**Furman Sound, Inc.**  
**RV-1 Reverberation System with Limiter**

SCALE	SIZE	DRAWING NO.
DO NOT SCALE	B	RV-005
		FS 101-05

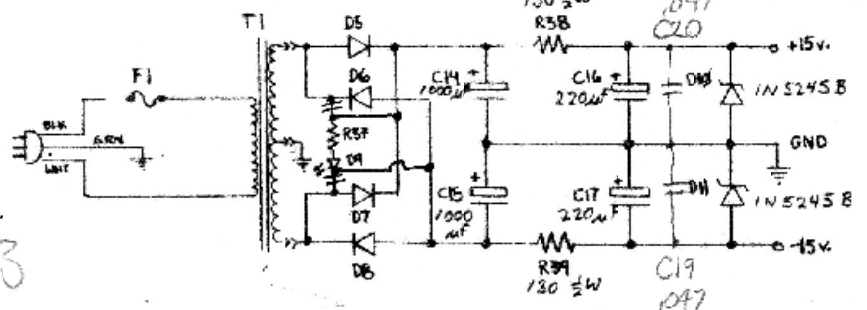
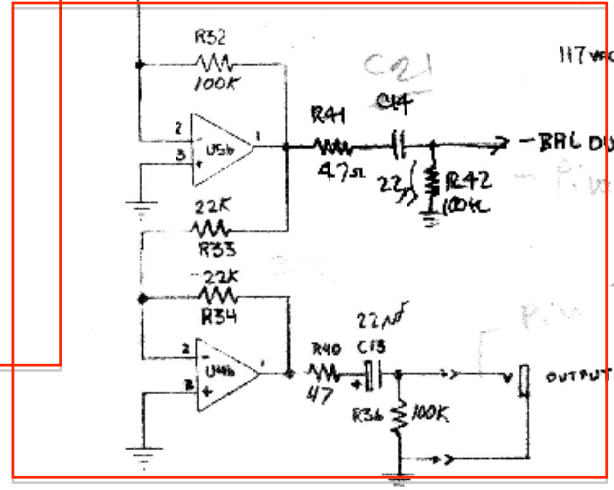
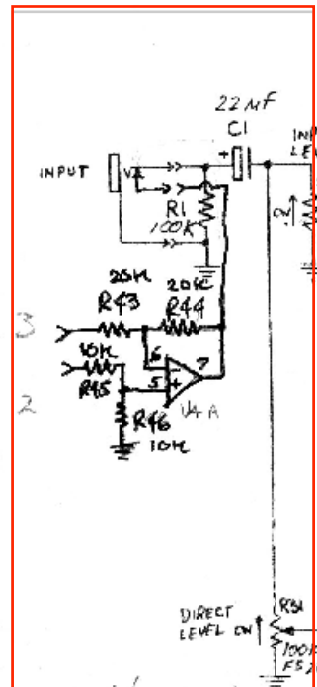
11k/14V 1.273 mA  
WILL MAKE R4 ≈ 15K

input/output  
lead dress  
is critical/  
simly possible  
(excess wire)  
RC .0033 2.2K  
pin 3 u Ground  
Barly coils  
Vcc &

# starting with serial # C4207

TOLERANCES UNLESS OTHERWISE SPECIFIED FRACTIONS DEC ANGLES		Furman Sound, Inc.	
± ± ±		RV-1 Reverberation System with Limiter	
APPROVALS	DATE	SCALE	SIZE
DRAWN JHL	05 NOV 78	1:1 NOT SCALE	B
CHECKED JKF	17 JAN 79	DRAWING NO. RV-005	
FCB#: RV-05		FS 101-05	
DO NOT SCALE DRAWING			SHEET

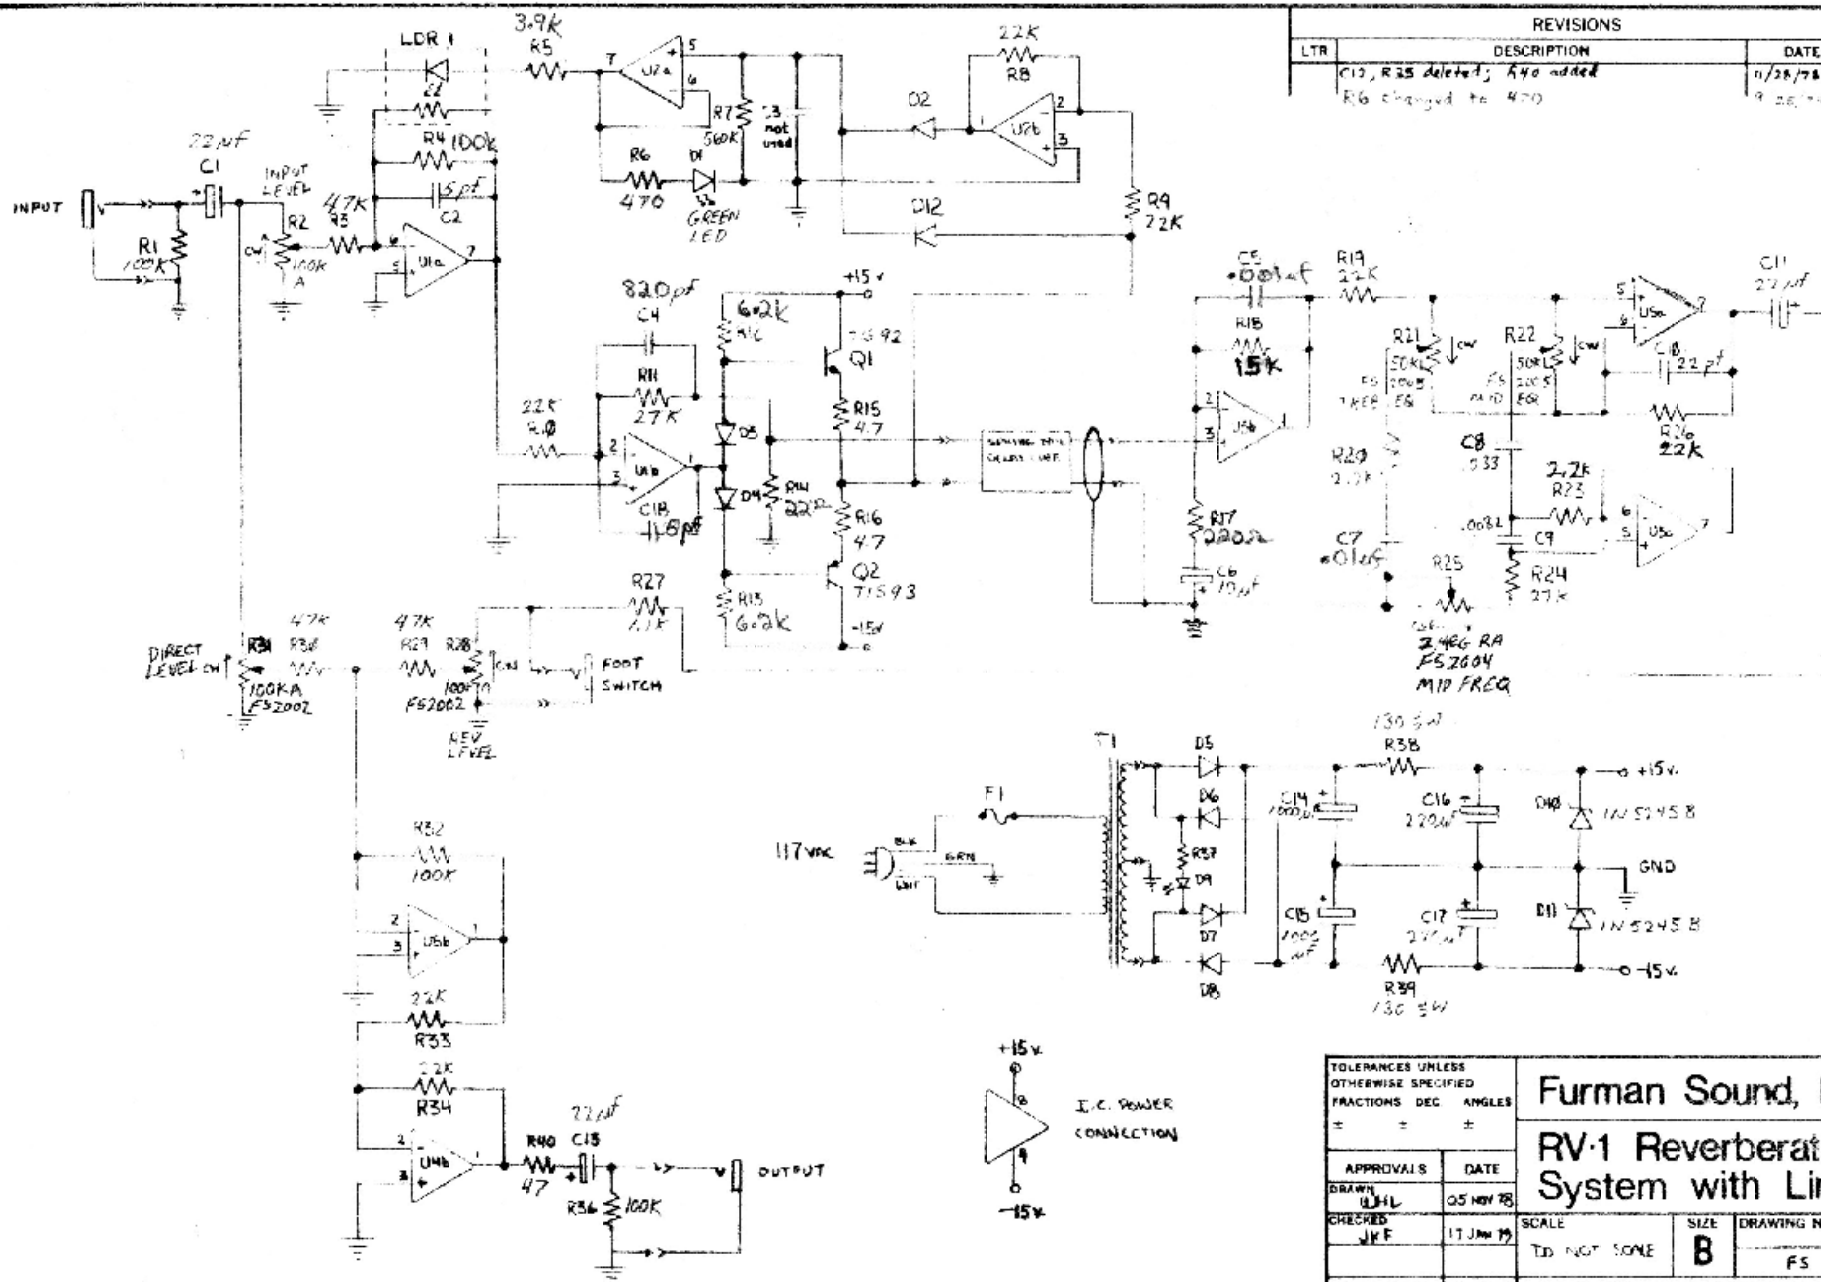
REVISIONS			
LTR	DESCRIPTION	DATE	APPROVED
	C15, R35 Deleted; A40 added	11/28/78	JKF
	R6 changed to 470	9/28/78	JKF
